**STATE OF CONNECTICUT
CONNECTICUT SITING COUNCIL**

**Petition of BNE Energy Inc. for a
Declaratory Ruling for the Location,
Construction and Operation of a 4.8 MW
Wind Renewable Generating Project on
Winsted-Norfolk Road in Colebrook,
Connecticut (“Wind Colebrook North”)**

Petition No. 984

PRE-FILED TESTIMONY OF WILLIAM F. CARBONI

FIGURE 1
Area tributary to Temporary Sediment Trap 3 and Stormwater Pond 1

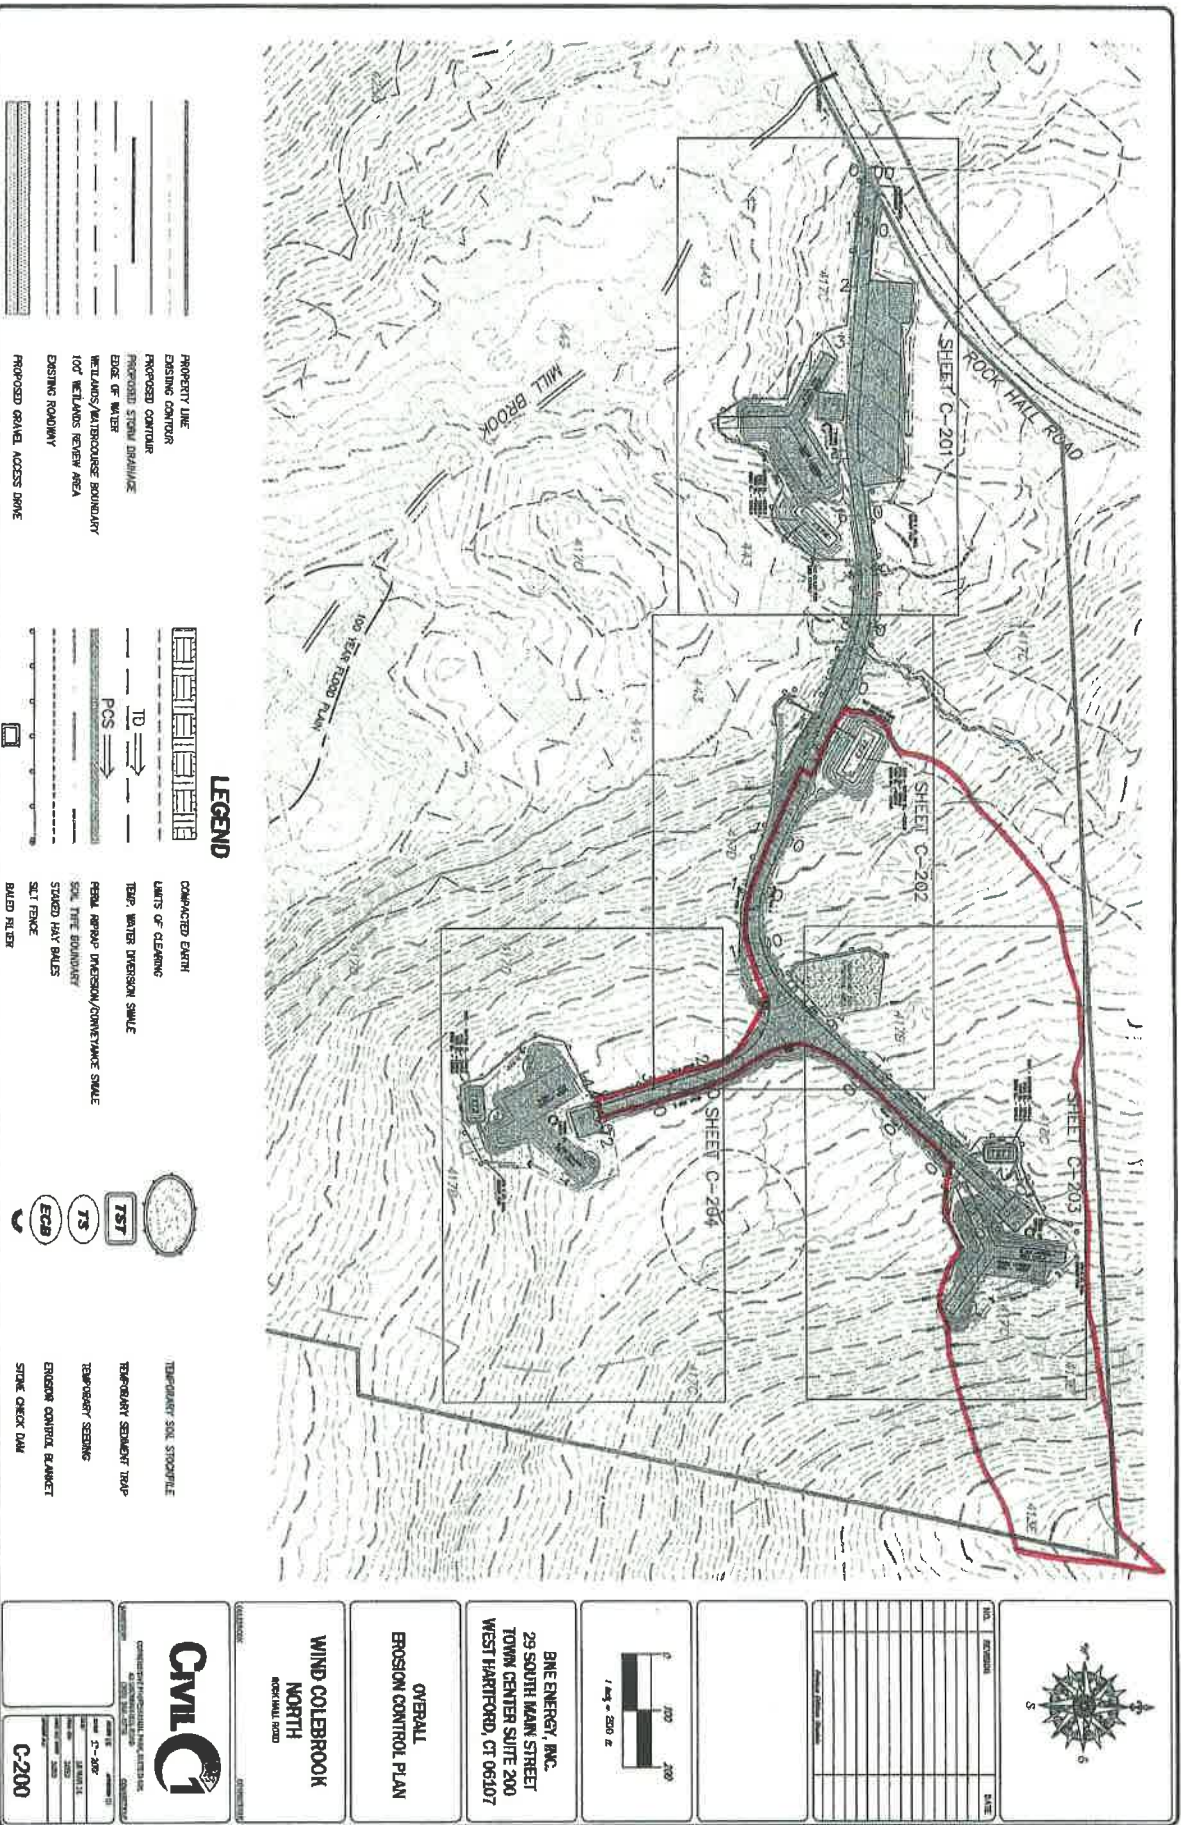
A31. Yes. The watershed boundaries are not accurately depicted in the studies. In particular, the area tributary to Temporary Sediment Trap ("TST") 3 and Stormwater Pond 1 is underestimated. These facilities are in the same location and should have the same tributary area. There is no boundary map provided in the Stormwater Management Plan. Attached to my testimony is Figure 1, which shows the area tributary to TST 3 and Pond 1. According to my analysis, the tributary area is approximately 10.9 acres. In Appendix K, the sediment trap sizing calculation shows the area drainage area to be 3.60 acres. (C. Jones Pre-Filed Testimony, Ex. 3, App'x K (Supporting Calculations).) In Appendix K, the input data for the detention analysis shows the area disturbed to the same location to be 4.70 acres. (C. Jones Pre-Filed Testimony, Ex. 3, App'x K (Post-Development Drainage Calculations).)

The underestimation of the tributary areas has significant consequences for the design of the facilities required to protect the water quality. First, the sediment trap shown on the plans should be a sediment basin, because the 2002 Guidelines require the use of a sediment basin when the tributary area exceeds 5 acres. The criteria for sediment basins are more rigorous than those for a sediment trap. Mr. Jones states in his supporting calculations that the sediment trap provided is significantly oversized. In fact, it is less than half of the required size.

Stormwater Pond 1 is similarly undersized. The detention calculations show that the pond will have a water elevation of 1242.41 during a 100-year storm. The pond has a maximum usable elevation of 1242.50. If, as my analysis shows, the tributary area is more than twice the size that the pond was designed to handle, runoff will overtop the spillway and will not provide the necessary reduction in peak runoff.
